Our Ref: 211378 - Let 1 - Yapton

Re: Tree issues at land adjacent to Orchard Business Park, North End Road, Yapton, BN18 0GA

Photograph 1 – Tree protection rear of plots 1 and 2 on 07.06.21

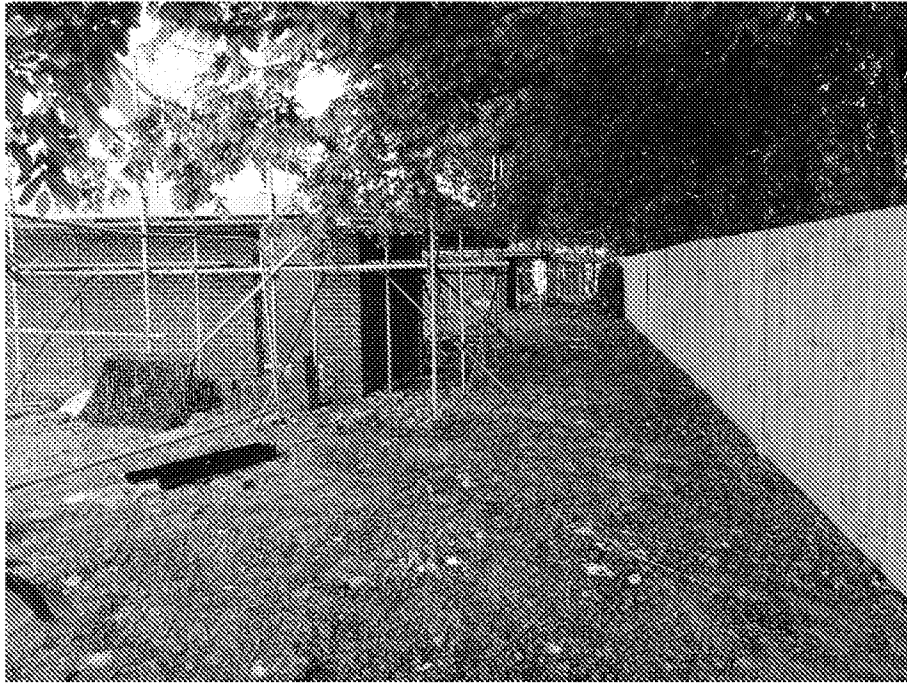
The tree protection barriers appeared to be generally in the positions shown on the Vivid Design Studio Proposed Hedgerow Protection Plan (photographs 1, 2 and 3). However, I did note that a couple of weld mesh panels had been displaced. Nonetheless, I thought that the positioning was generally acceptable in terms of providing a suitably distanced tree protection regime during the remainder of the construction phase.

During my visit I did note that there was a lack of bracing of the weld mesh panels and this (along with the displaced panels) needs attention, as I share the Tree Officers concerns regarding robustness. I noted that pins had been placed through the rubber block trays in order to deter movement, but my experience is that such a measure in isolation is likely to be insufficient to deter accidental displacement. I therefore advised that additional strut bracing should be considered at the same time as the repositioning of the errant panels.

I understand from our subsequent telephone conversation that the tree protection barriers have now been braced more securely using rear facing struts pinned to the ground and that the displaced panels are now in position. You sent me images (photographs 4, 5 and 6) showing the revised more securely braced and pinned tree protection. In my view, this is a significant improvement over the tree protection I noted during my visit and I would now suggest that this is generally in accordance with Figure 3 of *BS 5837:2012 Trees in relation to design, demolition and construction – Recommendations*. This diagram shows weld mesh panels with stabiliser struts mounted on their block trays and is not dissimilar to that shown in your photographs.

Photograph 4 – Updated and current tree protection rear of plots 1 and 2

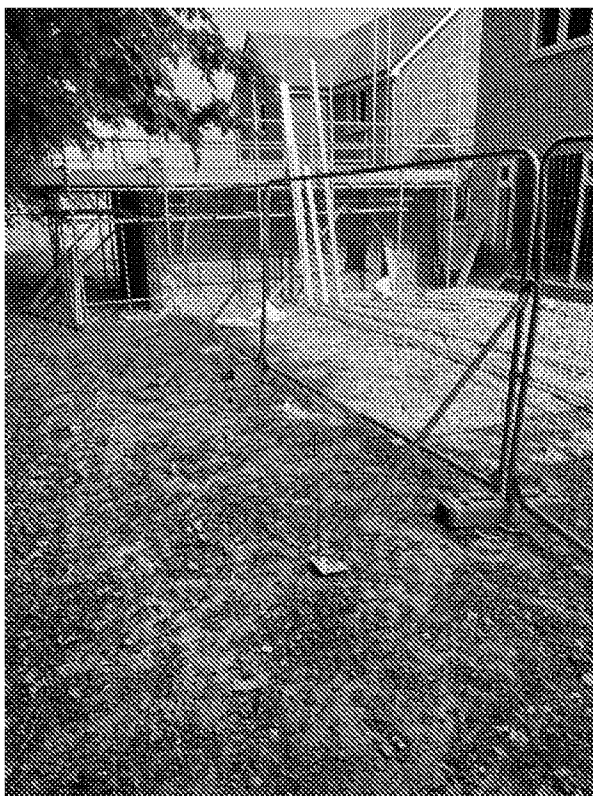
In summary, I feel that the updated tree protection indicated in your photographs is probably adequate now in terms of protecting the trees during the construction phase. However, the adequacy of the measures needs to be monitored during the remainder of the build phase and steps taken to rectify any deficiencies. My advice would be to now contact the councils Tree Officer, send him a copy of this report and seek his views on whether he is now content with the tree protection measures currently shown.
